Subject: Notification of a Class 1 Permit Modification to the Waste Isolation Pilot Plant
Hazardous Waste Facility Permit Number: NM4890139088-TSDF

Update Panel Closure Information

**Waste Isolation Pilot Plant
Carlsbad, New Mexico**

WIPP Permit Number - NM4890139088-TSDF

Figure G-1
Location of Underground HWDUs and Anticipated WPC Locations

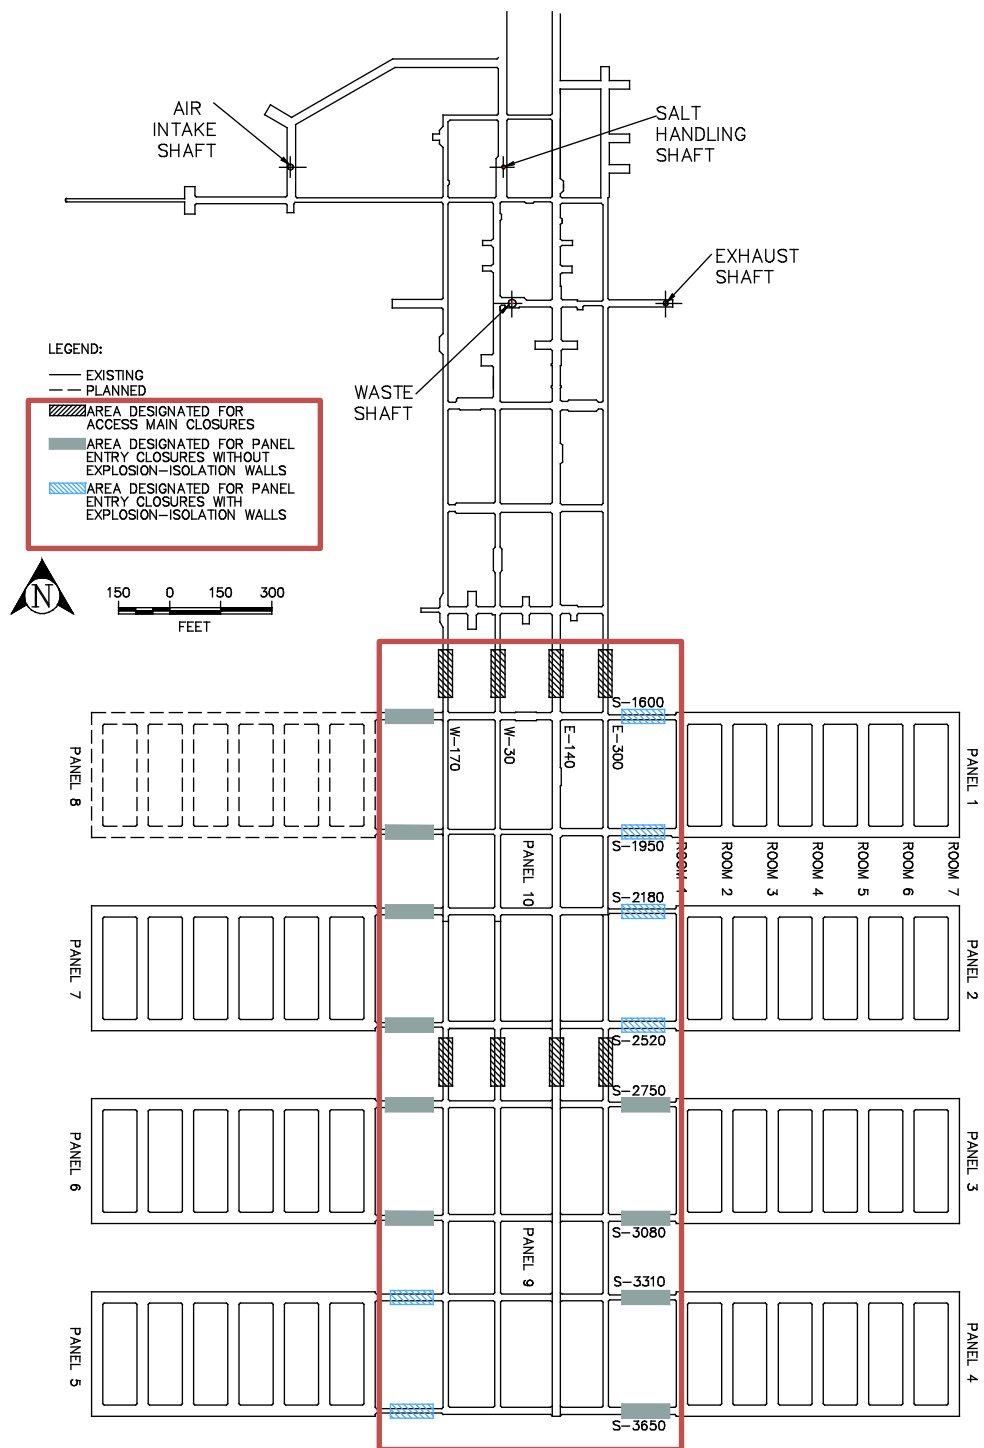
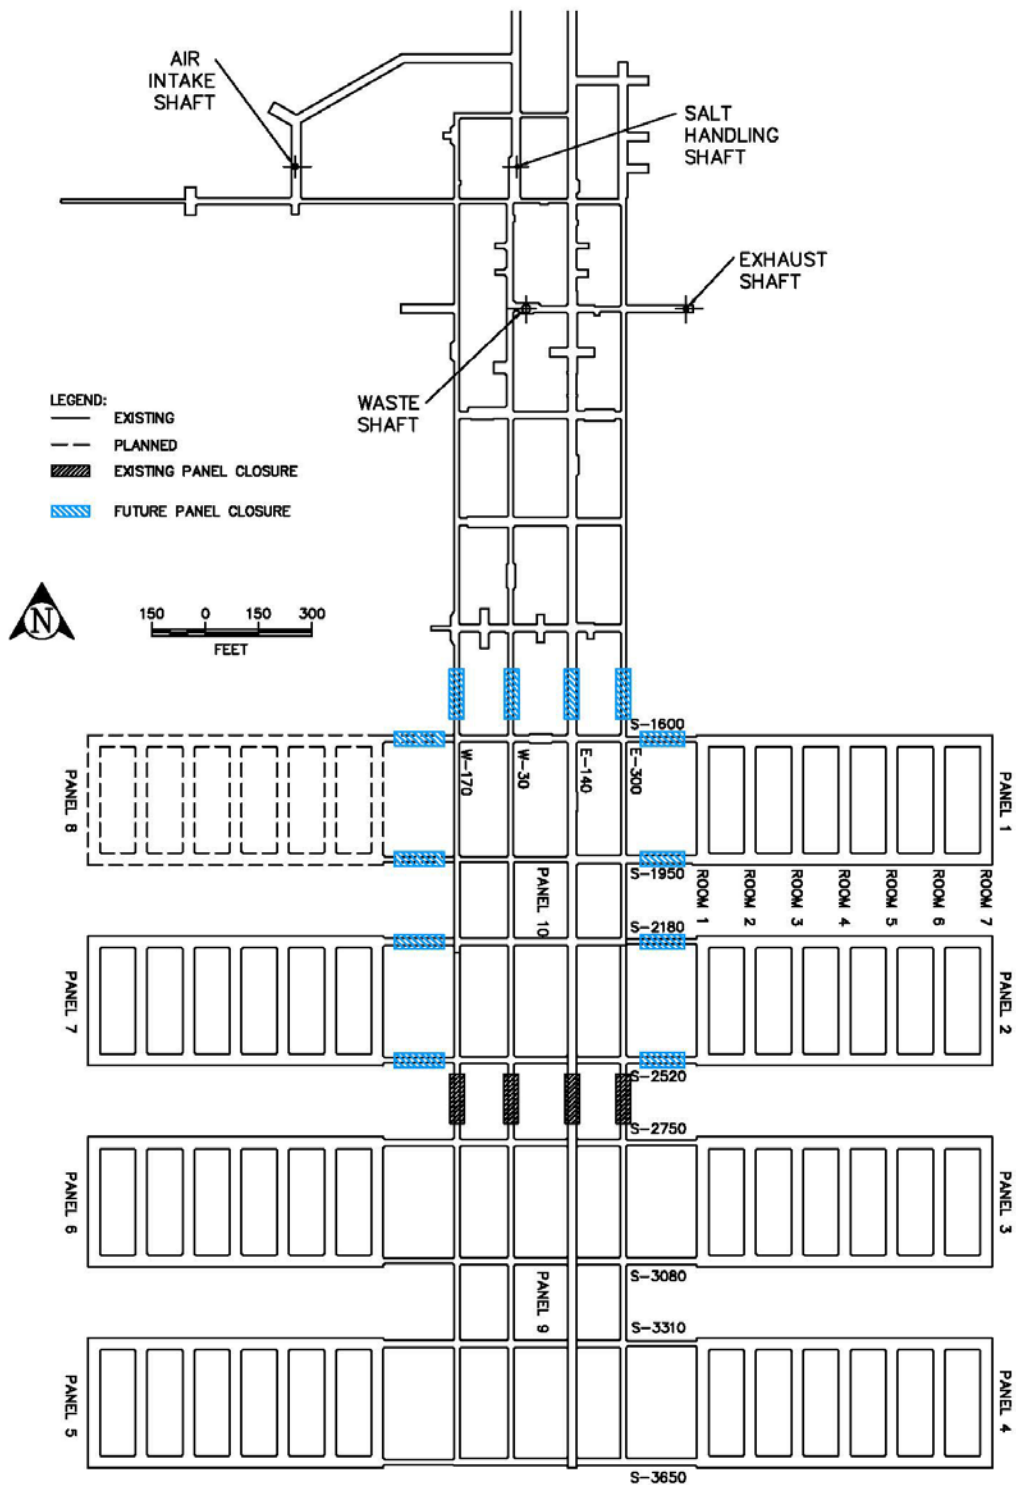
Assembly Areas; Permit Attachment G, Figure G-1, Location of Underground HWDUs and Anticipated WPC Locations; Permit Attachment G, Figure G-6, Approximate Locations of Boreholes in Relation to the WIPP Underground

- Changed “AREA DESIGNATED FOR ACCESS MAIN CLOSURES” to “EXISTING PANEL CLOSURE” in the figure legend.
- Removed “AREA DESIGNATED FOR PANEL ENTRY CLOSURES WITHOUT EXPLOSION-ISOLATION WALLS” from the figure legend.

- Changed “AREA DESIGNATED FOR PANEL ENTRY CLOSURES WITH EXPLOSION-ISOLATION WALLS” to “FUTURE PANEL CLOSURE” in the figure legend.
- Revised the markers on the underground layout to correspond with the new figure legend as follows:

- Changed the markers for the Panels 1, 2, 7, 8 and 10 closures to future panel closures.
 - Changed the markers for Panel 9 to existing panel closures.

- Permit Attachment G, Figure G-1, *Location of Underground HWDUs and Anticipated WPC Locations* also change the following:
 - Changed the figure title from “Location of Underground HWDUs and Anticipated WPC Locations” to “Location of Underground HWDUs and WPC Locations.”

Figure G-6
Approximate Locations of Boreholes in Relation to the WIPP Underground

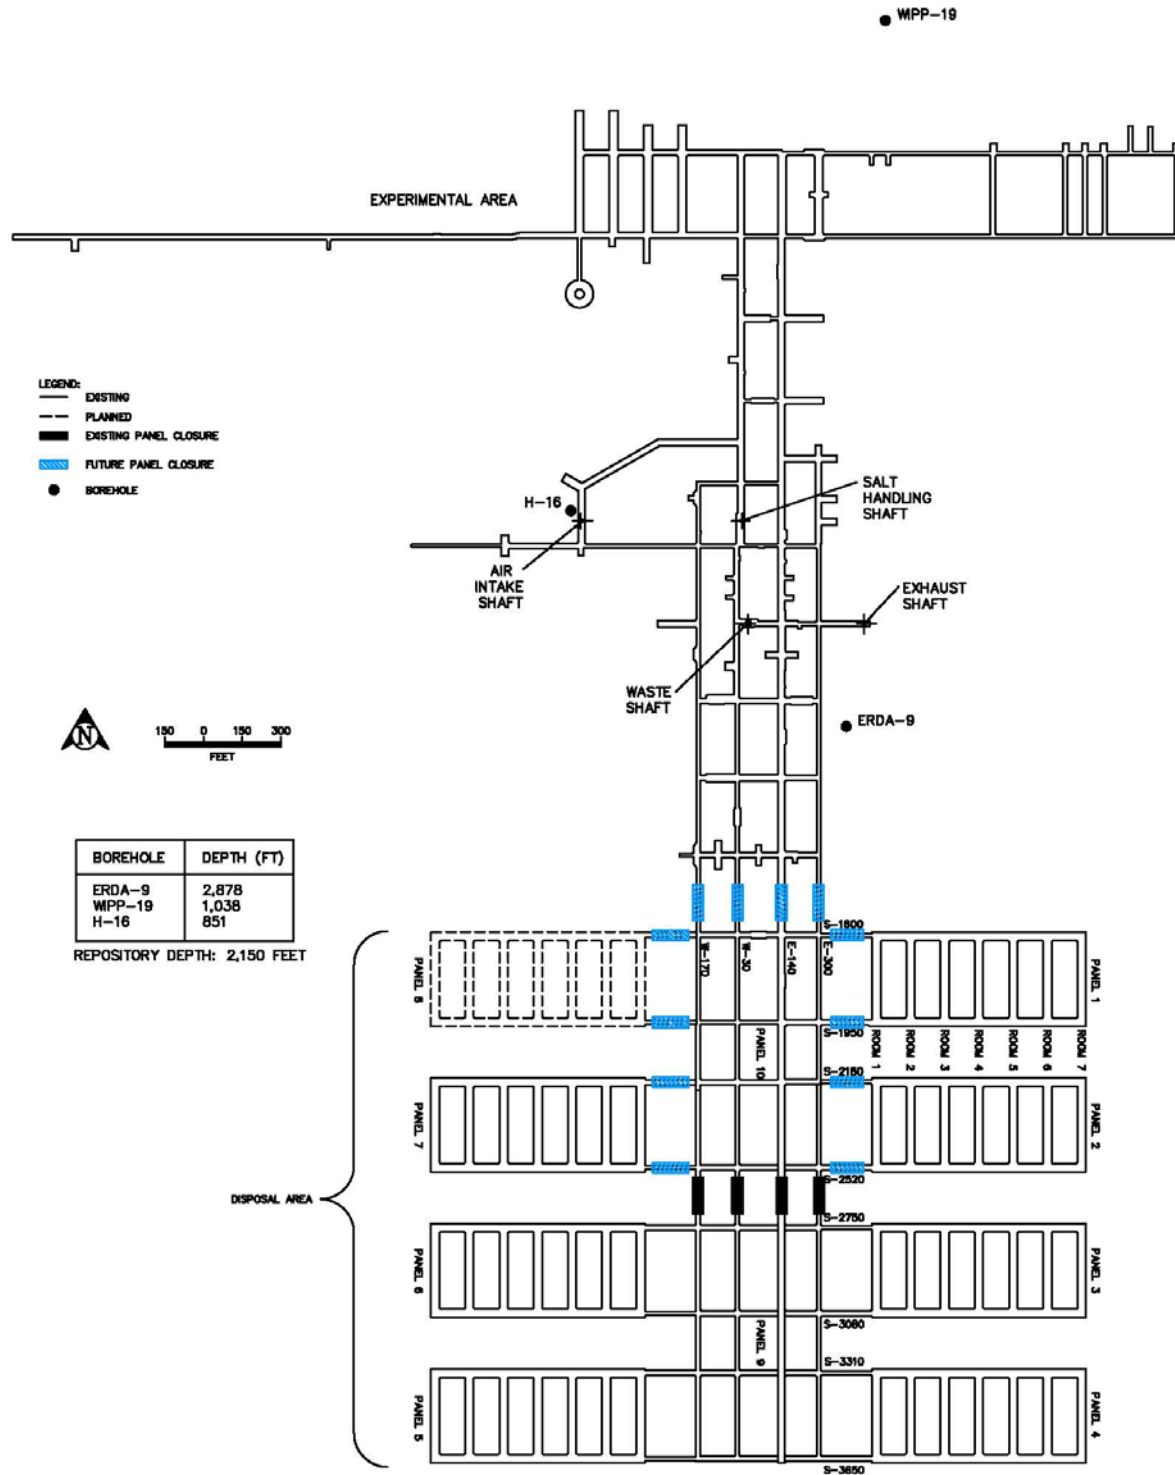
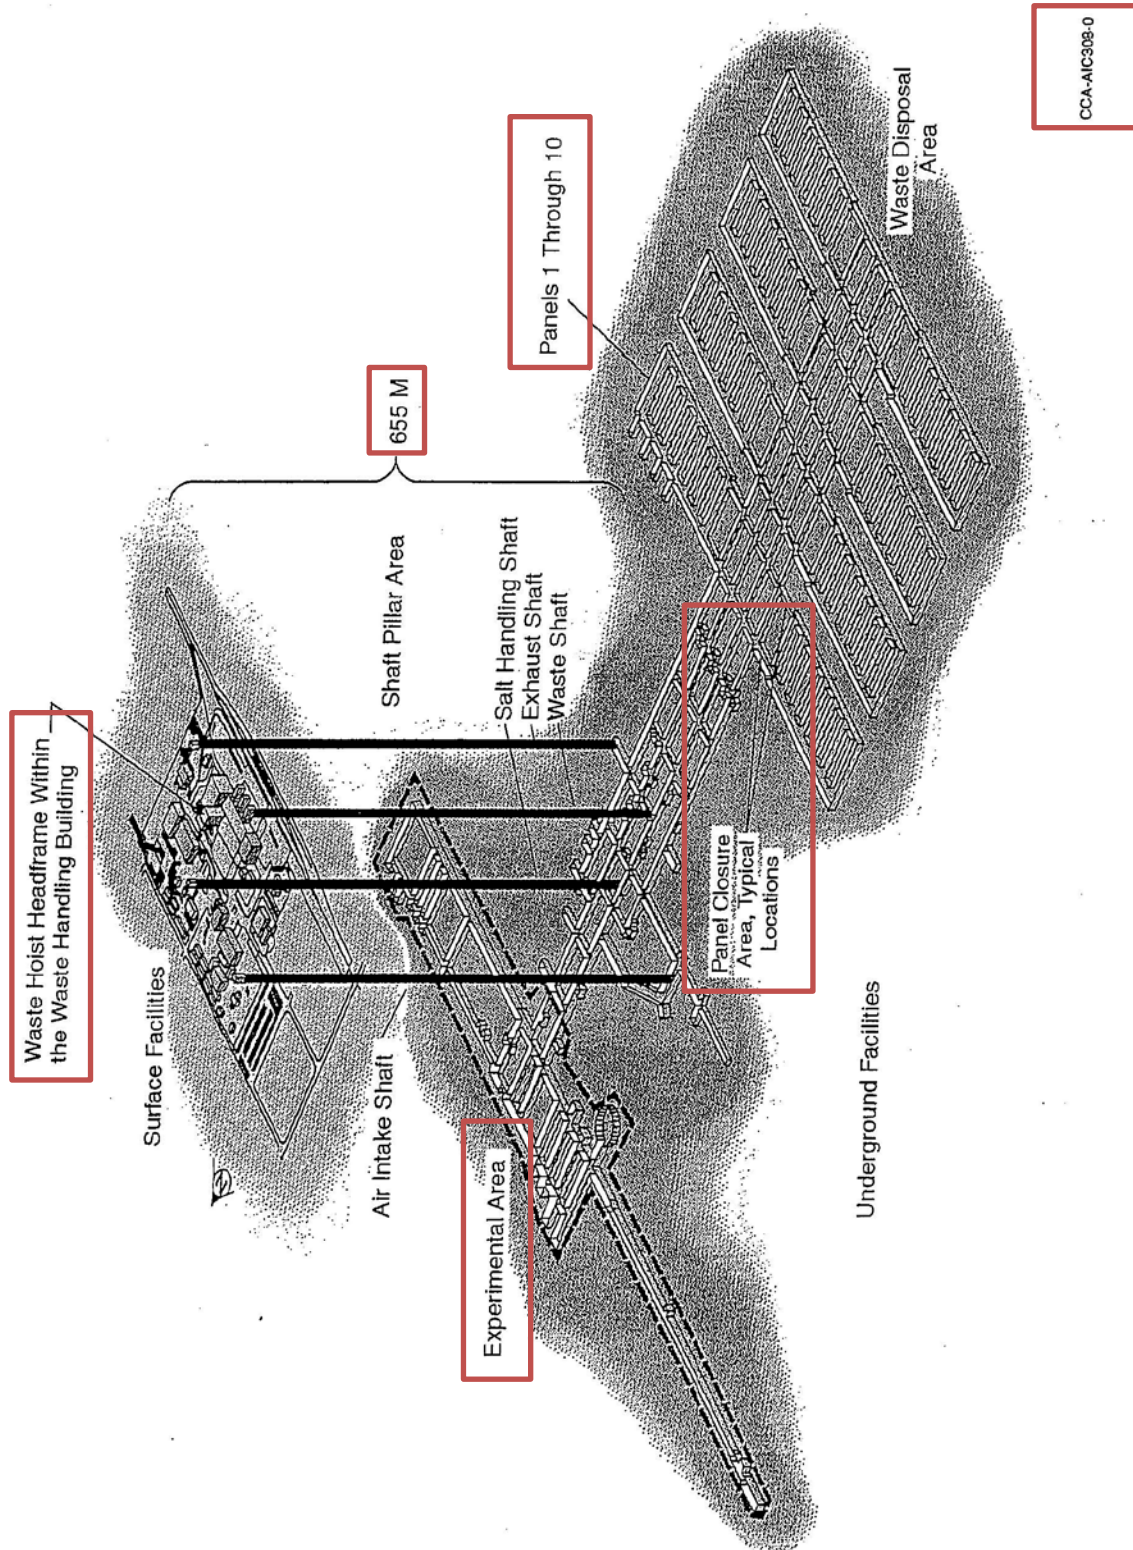
- Permit Attachment G, Figure G-6, *Approximate Locations of Boreholes in Relation to the WIPP Underground* also make the following editorial changes:
 - Added a comma to “2878” to read “2,878.”

- Added a comma to “1038” to read “1,038.”
 - Added a comma to “2150” to “2,150.”
 - Removed “BORE HOLE” from the ERDA-9 label to be consistent with the other borehole labels.

Figure H1-1
Spatial View of WIPP Surface and Underground Facilities

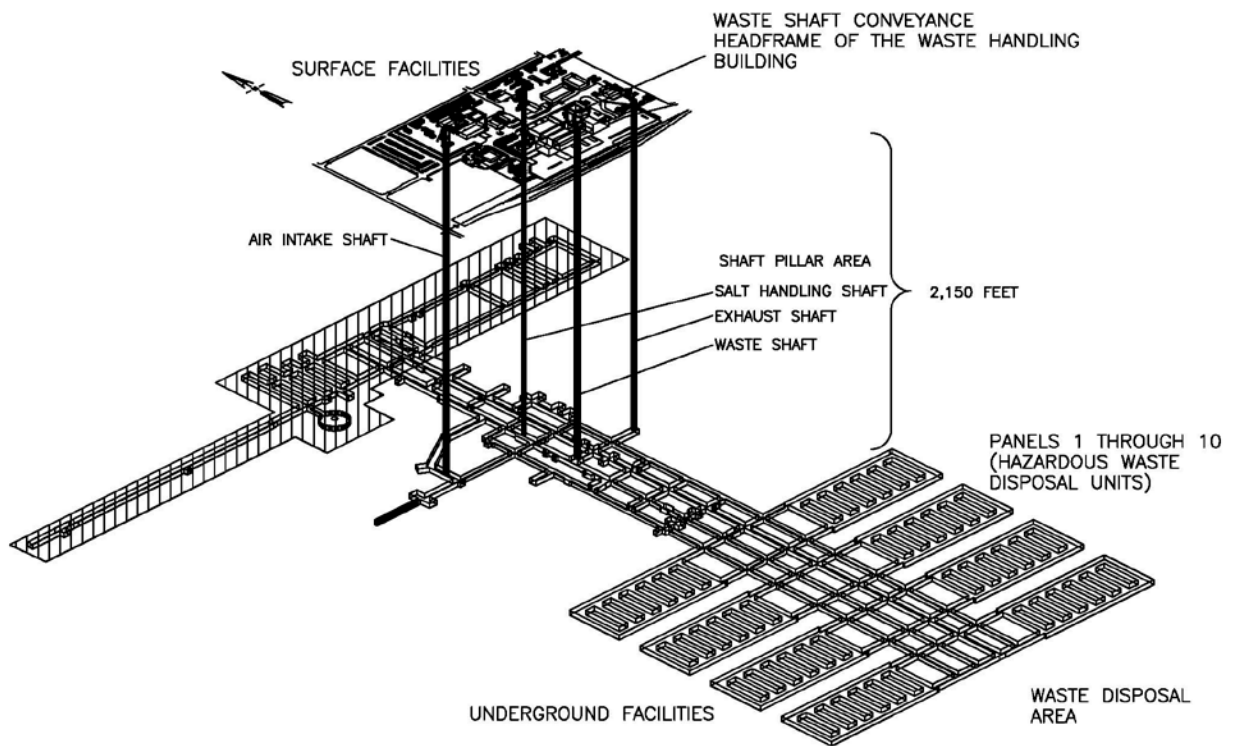
- Permit Attachment H1, Figure H1-1, *Spatial View of WIPP Surface and Underground Facilities*
 - Make figure consistent with the other figures in the Permit that depict the spatial view of the WIPP facility.

- Removed panel closure label.
- Changed “655 M” to “2,150 FEET.”
- Added “(HAZARDOUS WASTE DISPOSAL UNITS)” To “PANELS 1 THROUGH 10” label.
- Removed “Experimental Area” label.
- Changed “Waste Hoist Headframe Within the Waste Handling Building” label to “WASTE SHAFT CONVEYANCE HEADFRAME OF THE WASTE HANDLING BUILDING.”
- Capitalized the figure labels.
- Removed number in the lower right-hand corner of the figure.
